## **Non-Concurrence Process Record for NCP-2012-001**

TITLE OF SUBJECT DOCUMENT  
DIABLO CANYON POWER PLANT - INSPECTION REPORT 05000275/323-2011005

ADAMS ACCESSION NO.  
ML120450843

Figure 1  
Comparison of DE, DDE, & HE Horizontal Response Spectrum at the Steam Generators

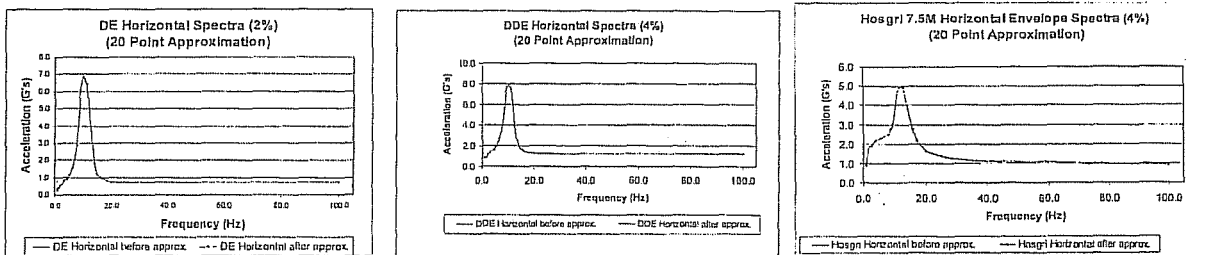
The HE represented the largest ground motion of the three design basis events. However, SSC seismic qualification was limited by each of the three design basis earthquakes. For example, the safety analysis predicted higher vibratory motion for DE and DDE than the HE at the steam generators, as shown in Figure 1. The bounding vibratory motion (shaking), used to seismically qualify individual plant components, was a function of the component location. As shown in Figure 2, the DDE provided the limiting floor response spectrum for the 88 foot level of the containment building. The seismic qualification of plant structures was also limited by both the DDE and HE, dependant on location. For example, the seismic qualification of the lower levels of the containment structure were limited by the HE design basis while the upper levels were dominated by the larger DDE spectrum. Portions of the reactor coolant pressure boundary were more limited by the DE and DDE than HE. These differences in qualification requirements resulted from different assumptions, methods, design basis values/inputs, and acceptance criteria approved for each seismic safety analysis.

The licensee's substitution of the HE design basis for demonstrating the DDE Code acceptance criteria were met was not an acceptance approach by either the licensee's operability procedure or the NRC operability guidance. This was a concern because in many cases, the reactor coolant pressure boundary stress was more limiting for the DDE than HE (see Figure 1).

Figure 2  
Comparison of DDE and HE Containments Floor Response at 88 Foot

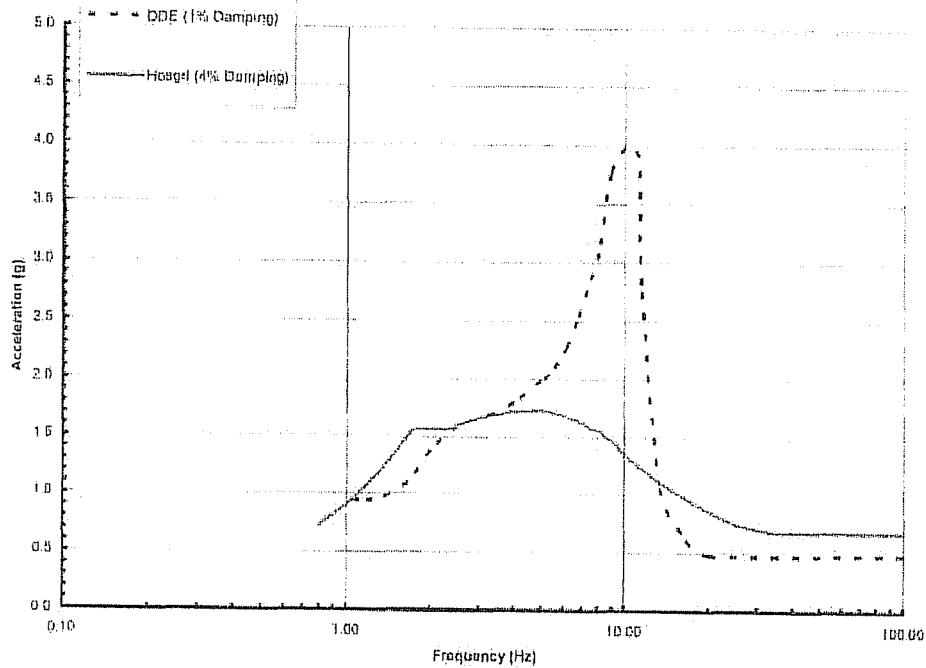
In many cases the DDE safety analysis provided the bounding vibratory motion used to establish the seismic qualification for plant SSC. For example, the FSARU credited the containment fan coolers to mitigate the design basis loss of coolant and steam line break accidents. The design basis required these coolers to be qualified to function following the vibratory motion (shaking) associated with the DDE. These coolers are located on the 88 foot level of the containment building. As shown in Figure 2, the DDE vibratory motion was greater than HE at this location. The POD was inadequate because the licensee failed to

demonstrate that the coolers would still function at the increased motion associated with the new seismic information for the DDE case.
